STAFF REPORT: PERMIT AMENDMENT

APPLICATION NO: 4-96-025-A-3

APPLICANT: Mark Jason

PROJECT LOCATION: 20556 Betton Drive, Topanga, Los Angeles County

Figure 1 - Site Vicinity Map

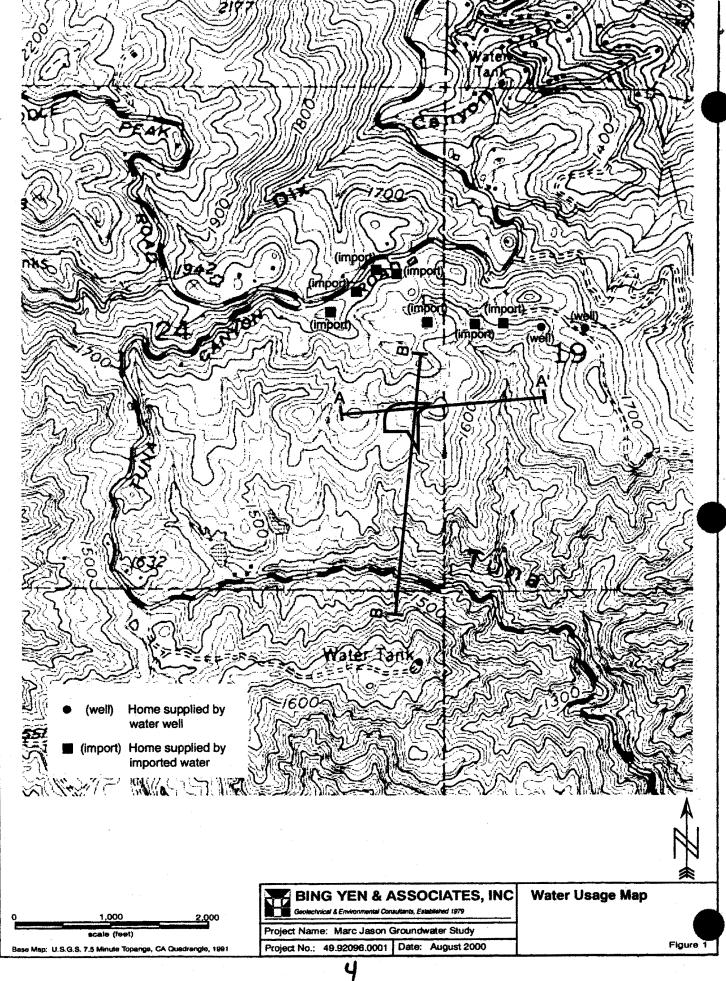
- 1. Provide additional information or references regarding the porosity and specific yield values assumed for the Sespe Formation.
- Provide the location of the nearby water wells identified in the referenced report.
- Evaluate the time-frame for groundwater recharged via septic system to recharge well.

- 2. The attached map illustrates the locations of the nearby water wells. The "Frayne" well indicated in the report is depicted as "Jobbins" due to a change in ownership.
- 3. The time frame for septic discharge to recharge to the water table is dependant on the depth of the septic pits and the wetting-front seepage velocity in the unsaturated zone. Seepage velocity can be estimated by the equation:
